ZU1 SYSTEM BLOCK DIAGRAM

PROJECT : ZU1

Quanta Computer Inc.

Size	Document Number	Rev
	GMCH HOST(1 of 7)	3B
Date:	Tuesday, April 10, 2007	Sheet 5 of 39

HOST

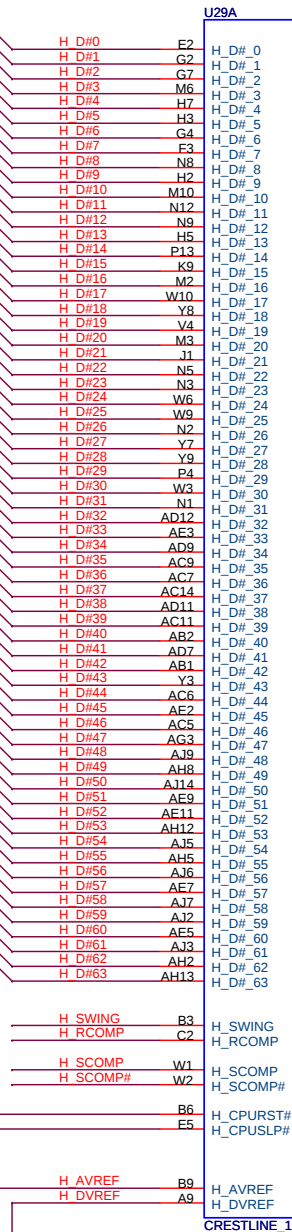
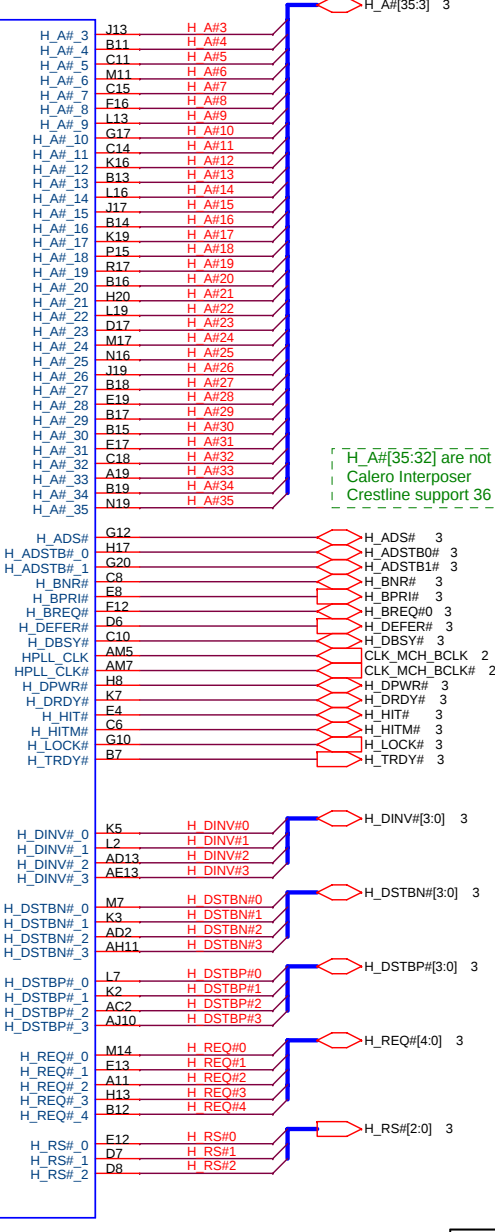
D3A: (2/1) Change 965GM from ES sample to QS sample
Change U29 P/N from AJ0QN120T37 to AJ0QP200T09

A1A: (9/20) remove R74 (0 ohm)

NB(Power-1)

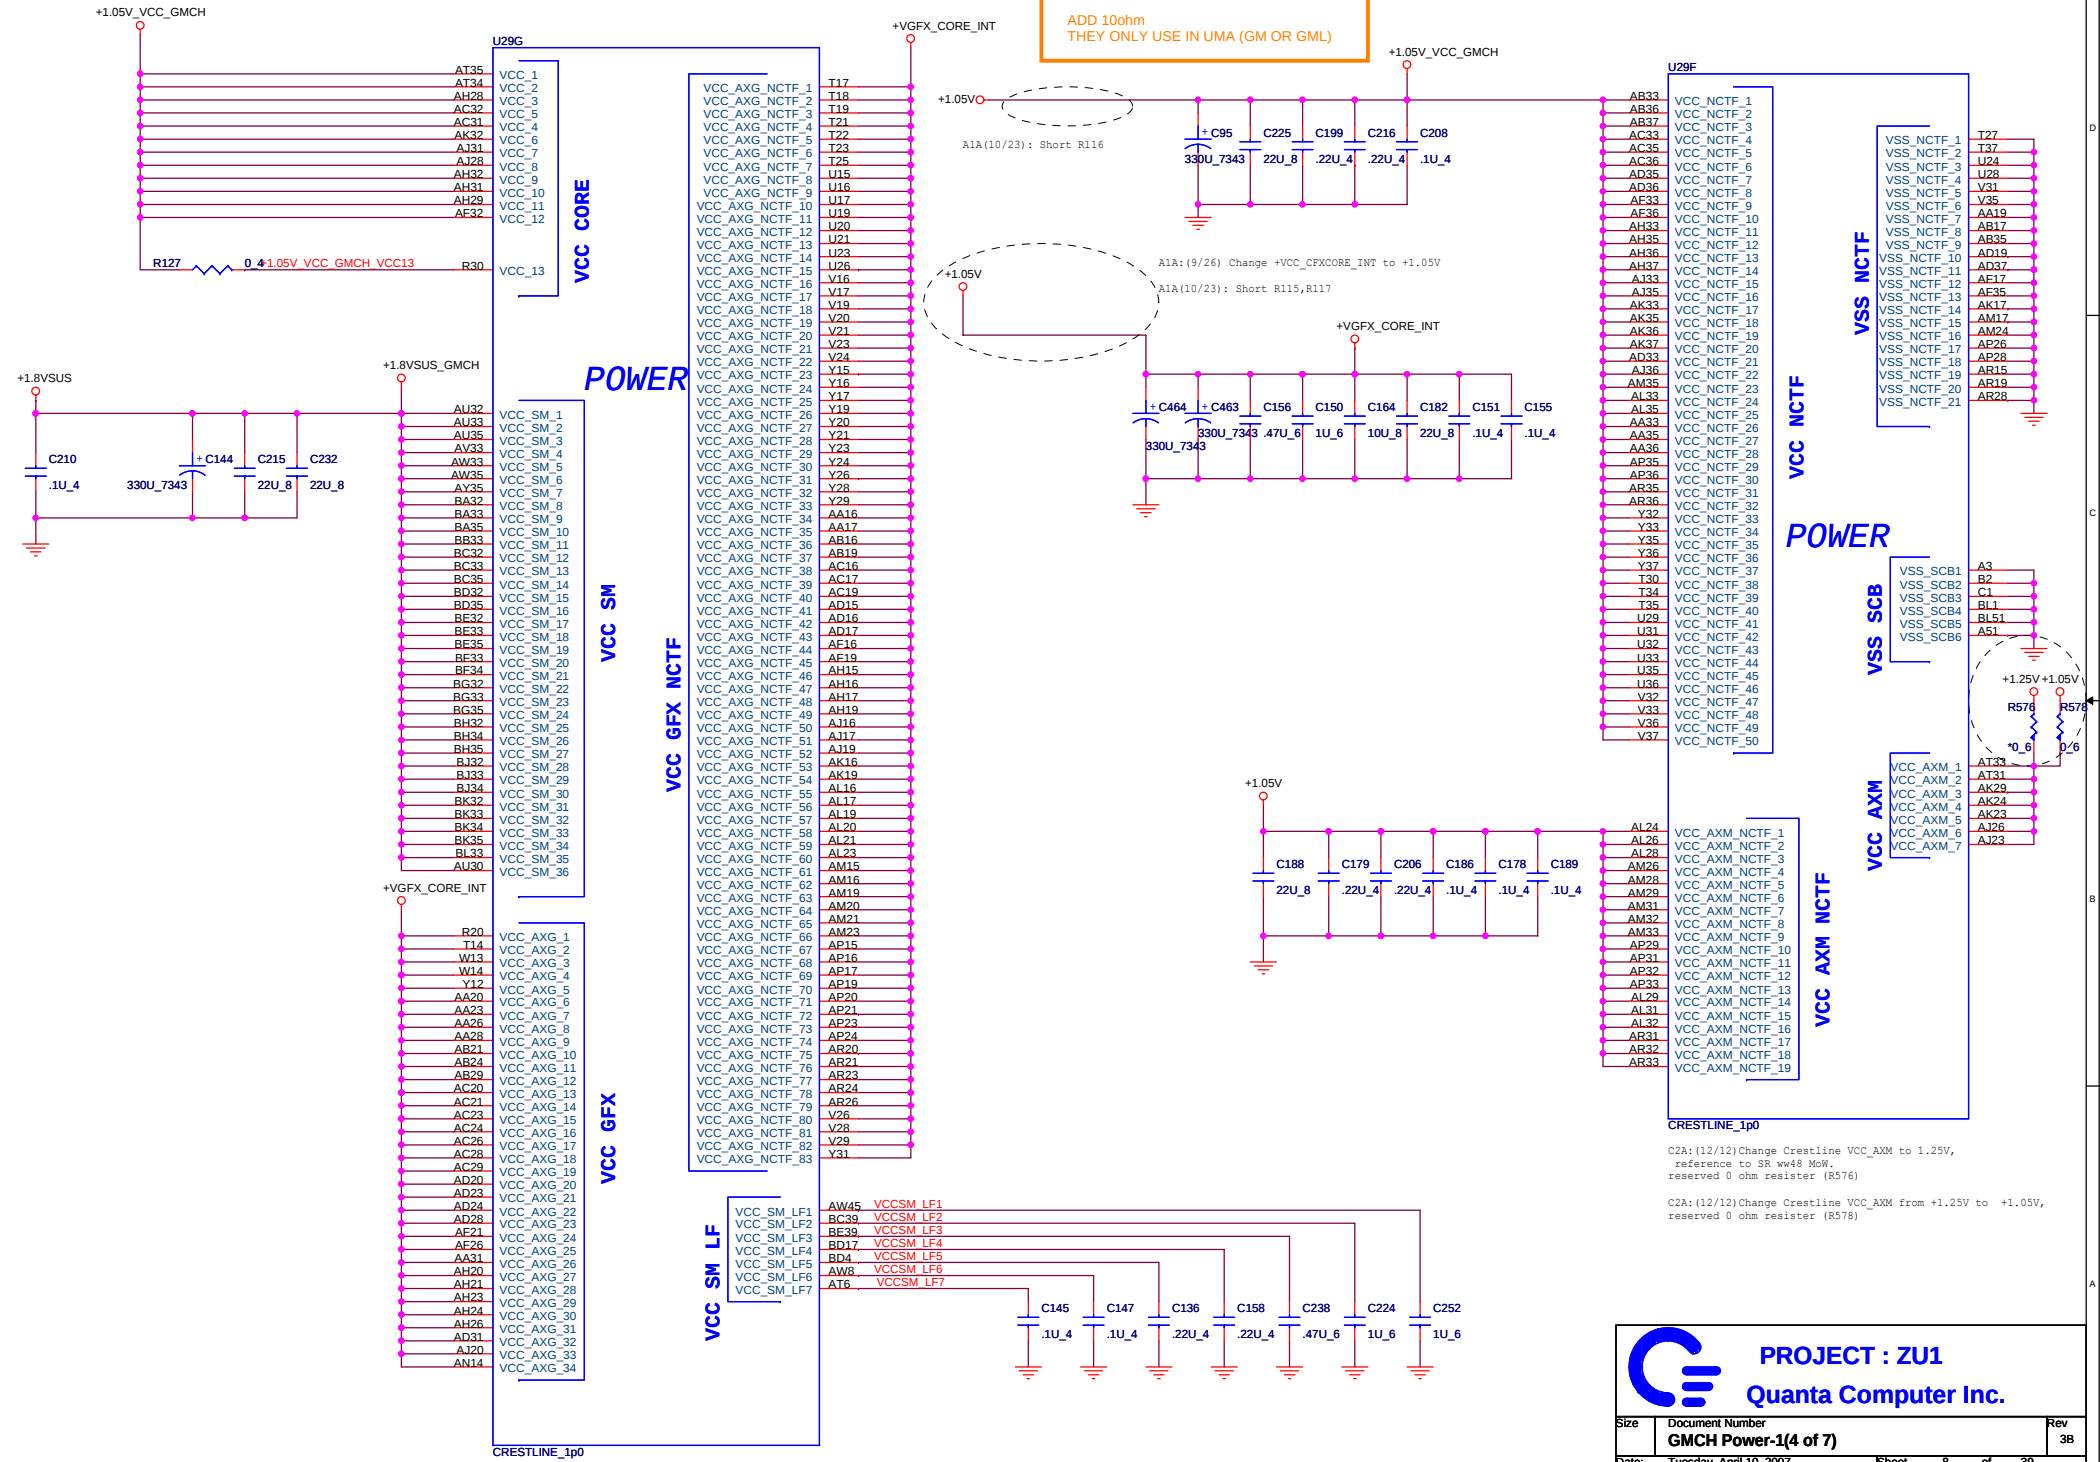
C2A: (12/12) Change Crestline VCC_AXM to 1.25V, reference to SR w48 MoM, reserved 0 ohm resistor (R576)

C2A: (12/12) Change Crestline VCC_AXM from +1.25V to +1.05V, reserved 0 ohm resistor (R578)

DDR2 Dual channel A/B CONN

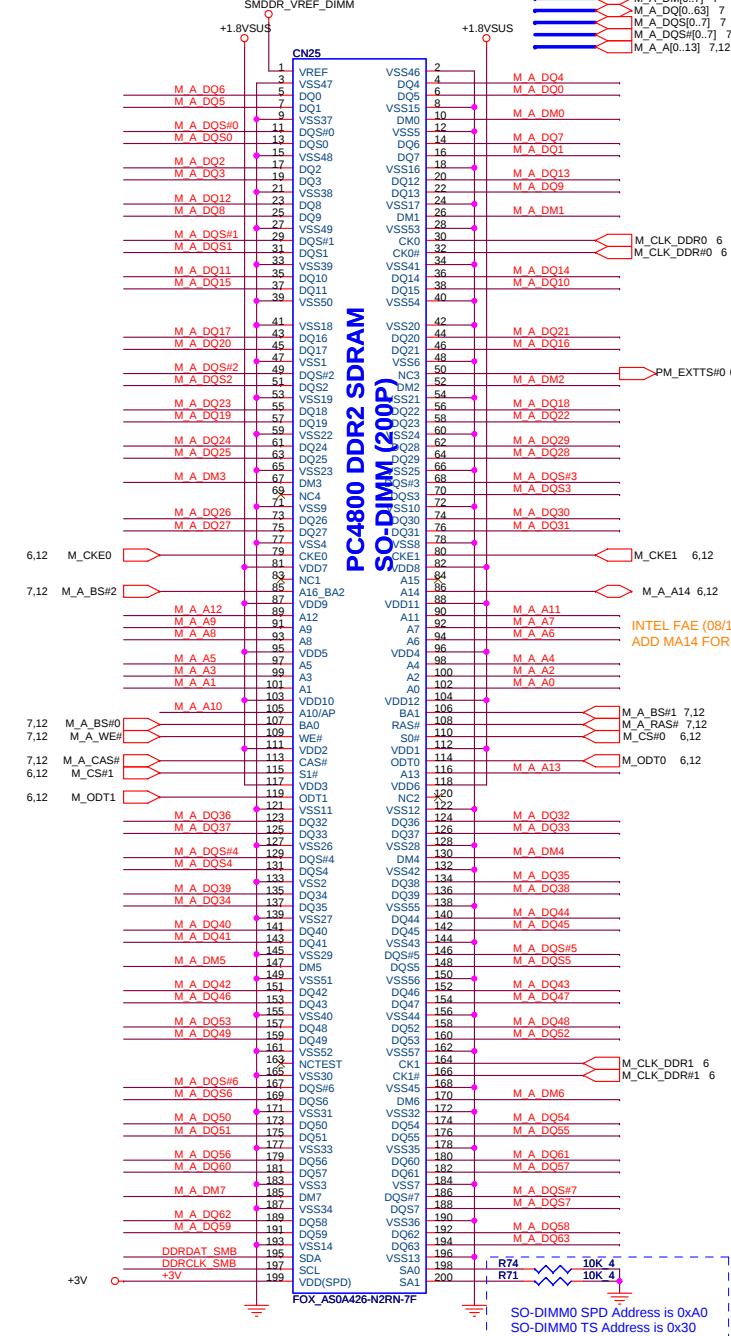
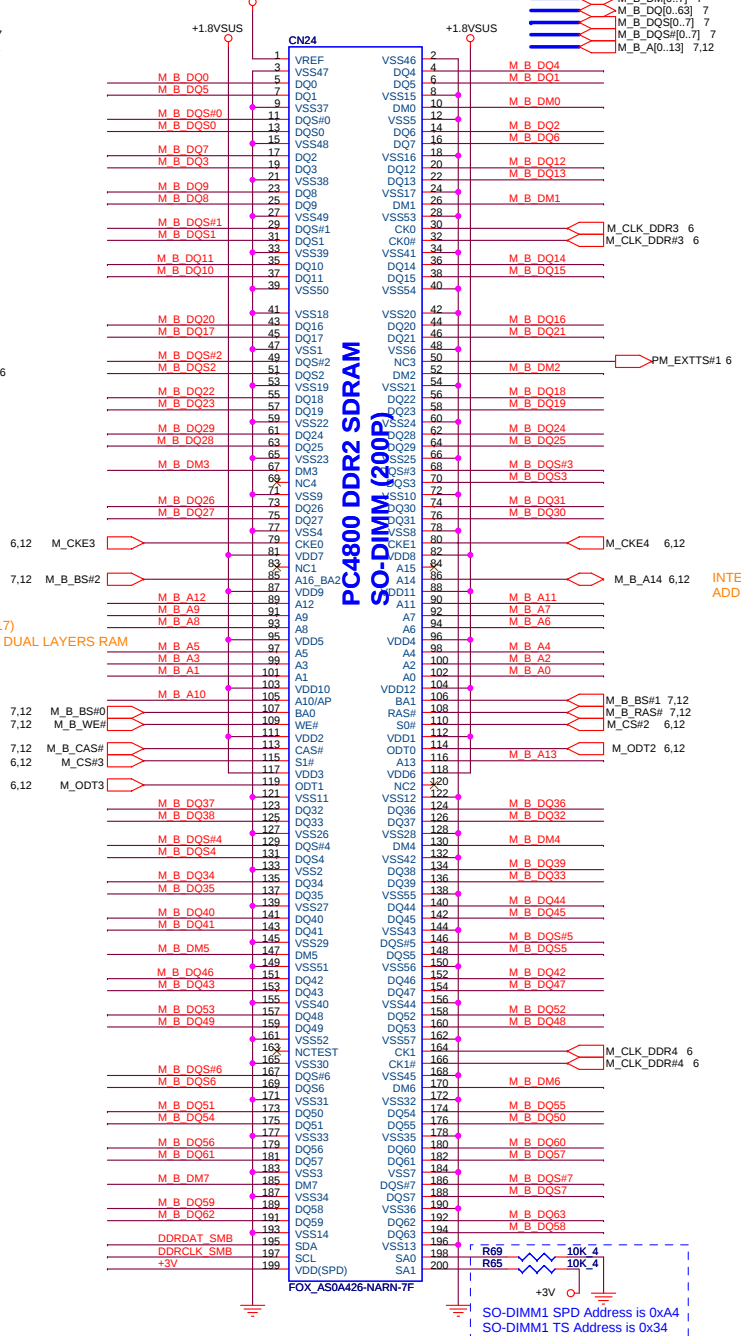
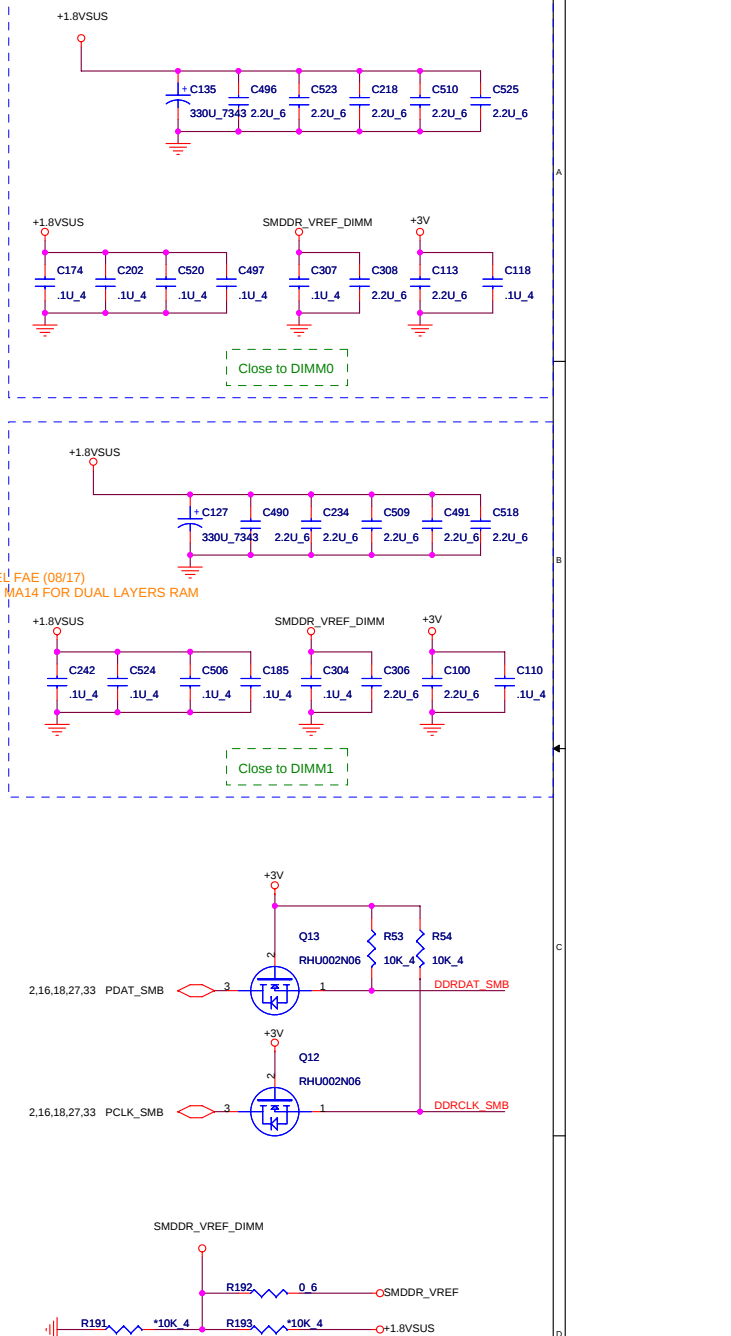
INTEL FAE (08/17)
ADD MA14 FOR DUAL LAYERS RAM

A1A: (10/30) no stuff R192, stuff R191,R193
A1A: (11/09) stuff R192, no stuff R191,R193

SB-GPIO

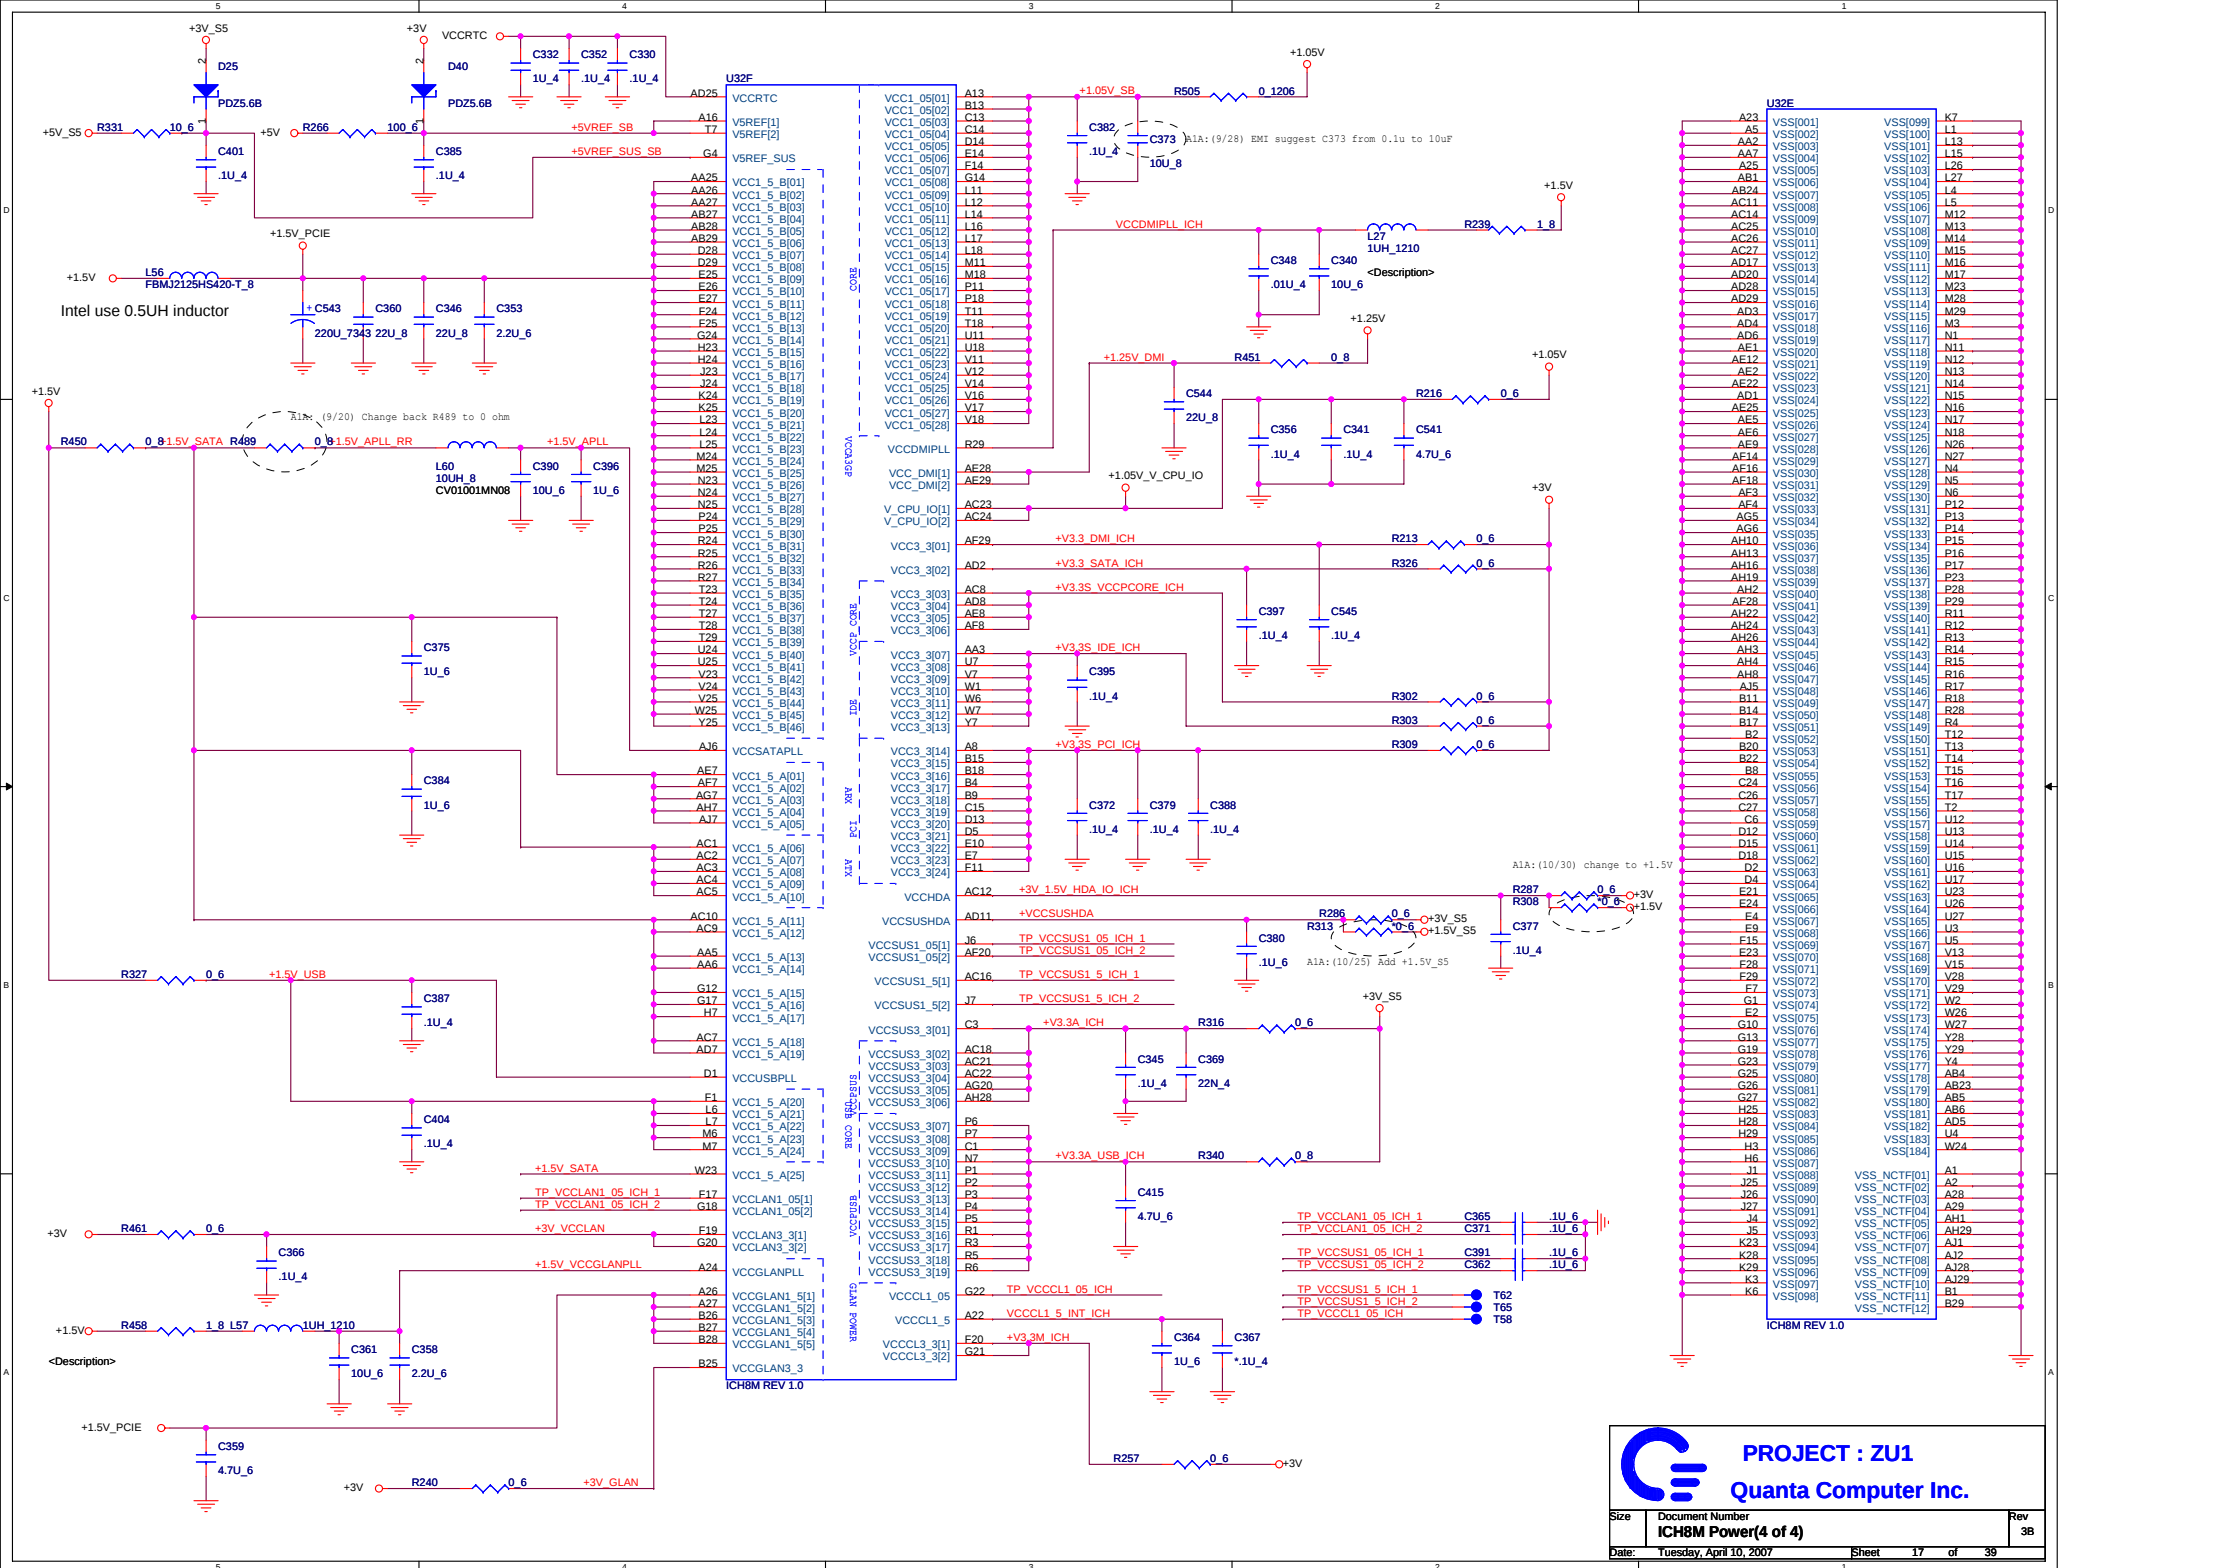
ECN 2A
INTEL CRB V1.301
CL_RST# NO NEED PU.

Remove PU +3V_S5 circuit (R259/R258)

C2A: (12/12) Intel Suggest : ICH8M GPIO20 should not be pulled HIGH.
